# Access Compliance Report

## Public Rights-of-Way

Intersection ID: 23533	Main Street: QUAIL_FOREST_DR	Cross Street: QUAIL_HOLLOW_RD	Location: NE
ADA ID: C22B410D358A	Ramp Type: PerpDiag	Initial Pass/Fail: Fail	Overall Compliance: No
		Severity Score: 10

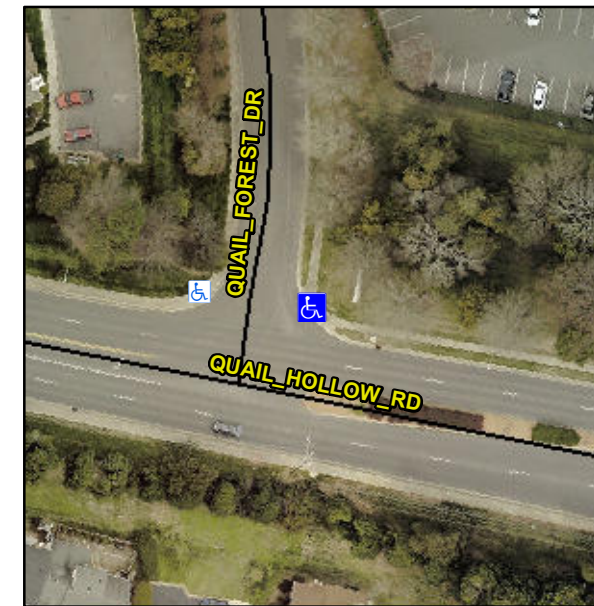
**Not Found, R304.5.1, R304.5.3**

Compliance	Description	Data	Compliance	Description	Data
N/A	Ramp Length (in)	58.0	Yes	Ramp Slope (%)	6.9
No	Ramp Width (in)	40.0	No	Ramp XSlope (%)	2.1
N/A	Flare Type LT	N/A	N/A	Flare Type RT	N/A
N/A	Flare Slope LT (%)	N/A	N/A	Flare Slope RT (%)	N/A
N/A	Flare Traversable LT?	N/A	N/A	Flare Traversable RT?	N/A
N/A	Landing Length (in)	N/A	N/A	DWS Provided?	N/A
N/A	Landing Width (in)	N/A	N/A	DWS Contrast?	N/A
N/A	Landing Slope (%)	N/A	N/A	DWS Length (in)	N/A
N/A	Landing X Slope (%)	N/A	N/A	DWS Full Width?	N/A
N/A	Landing Curb? (Y/N)	N/A	N/A	DWS Offset (in)	N/A
N/A	Shared Landing?	N/A			
N/A	Gutter Ponding?	N/A	N/A	Gutter Slope (%)	N/A
N/A	Gutter Lip Ht (in)	N/A	N/A	Gutter X Slope (%)	N/A
N/A	Painted X Walk1?	No	N/A	Painted X Walk2?	No
	X Walk 1 Direction	To NW		X Walk 2 Direction	To SW
N/A	X Walk 1 Width (in)	N/A	N/A	X Walk 2 Width (in)	N/A
	X Walk 1 Slope (%)	2.3		X Walk 2 Slope (%)	0.1
	X Walk 1 X Slope (%)	0.6		X Walk 2 X Slope (%)	1.0

**Remove & Replace Curb Ramp With Two New Directional Ramps or Equivalent.**
